Decision No. 91030 NOV 20 1979

BEFORE THE PUBLIC UTILITIES COMMISSION OF THE STATE OF CALIFORNIA

In the Matter of the Application of
SOUTHERN CALIFORNIA EDISON COMPANY
for an Order Amending General Order
No. 95, "Rules for Overhead Electric
Line Construction", to amend Certain
Rules with Respect to Increasing the
Maximum Voltage where Sectionalized
Guy Wires are Required.

Application No. 58730
(Filed March 8, 1979)

FIG. 45

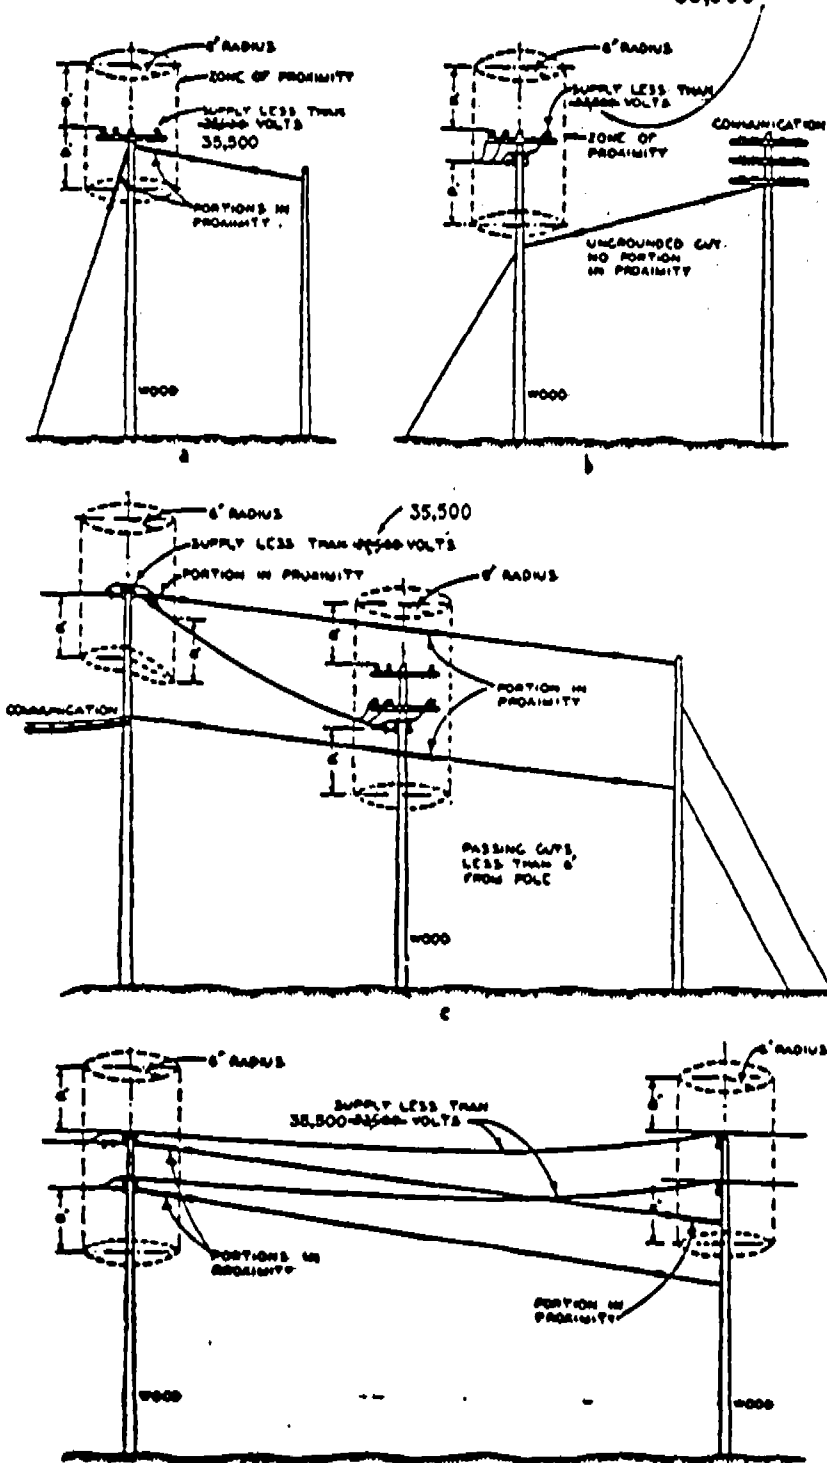
GUYS IN PROXIMITY TO WOOD POLES AND SUPPLY CONDUCTORS OF 35,500 VOLTS OR LESS.

RULES 21.3-D, 36.6-A AND 86.6. 35,500

FIG. 46

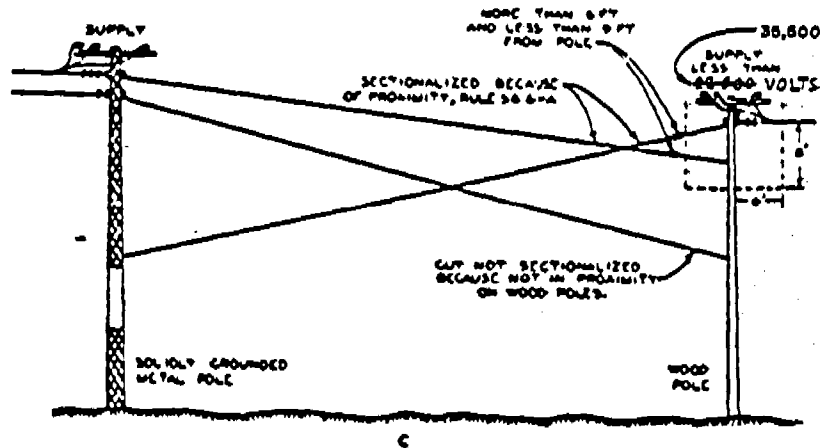
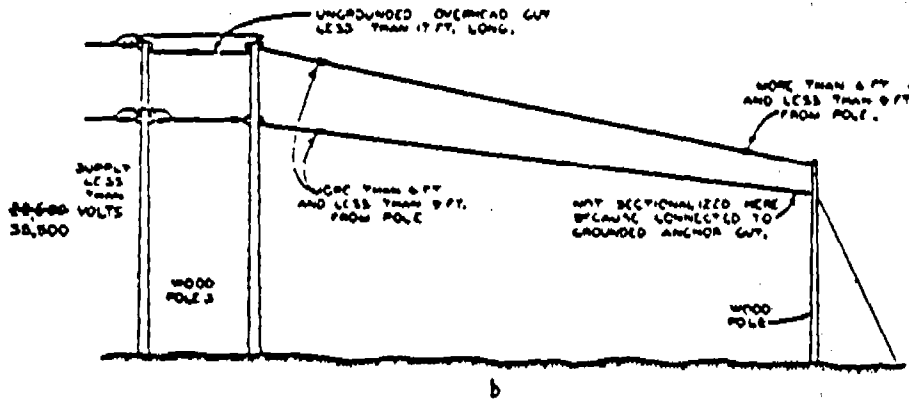
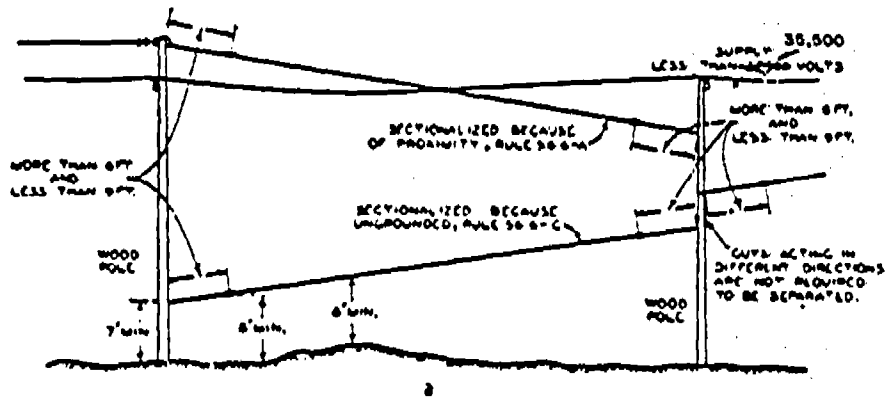
Revise Fig 46 as Indicated

FIG. 52

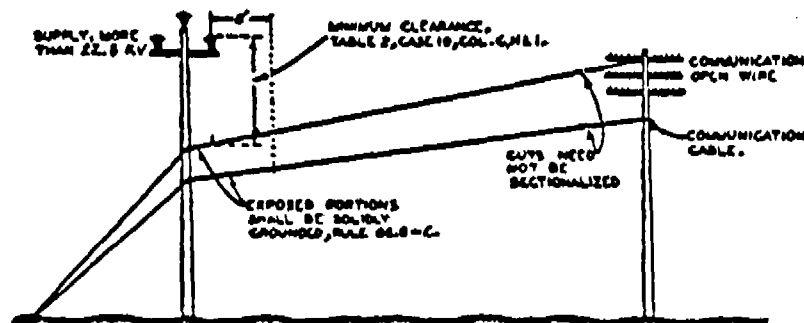
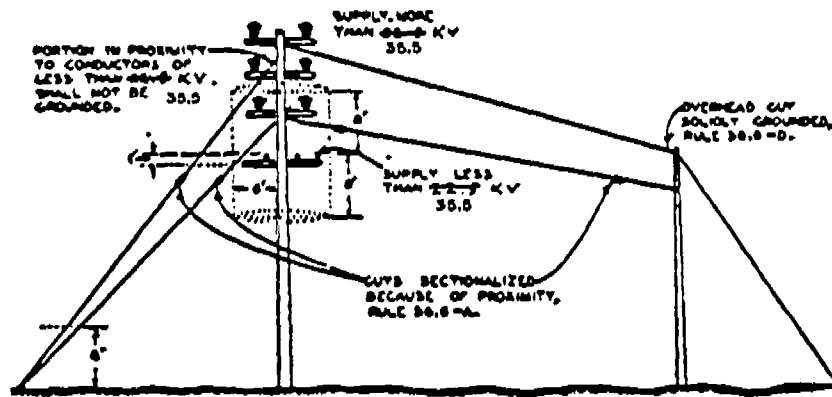
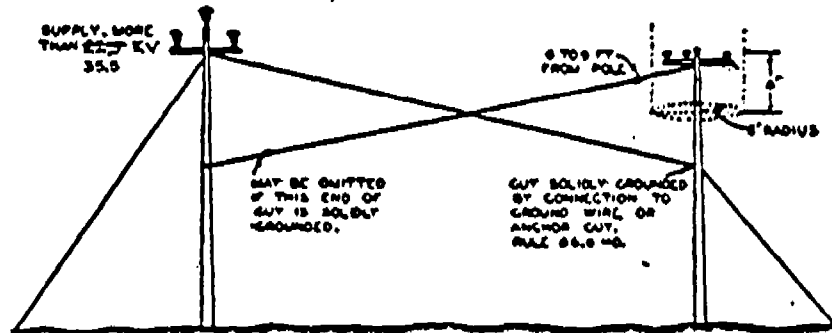
Revise Fig 52 as Indicated

OR IN PROXIMITY OF SUPPLY CONDUCTORS OF MORE THAN 35,500 VOLTS
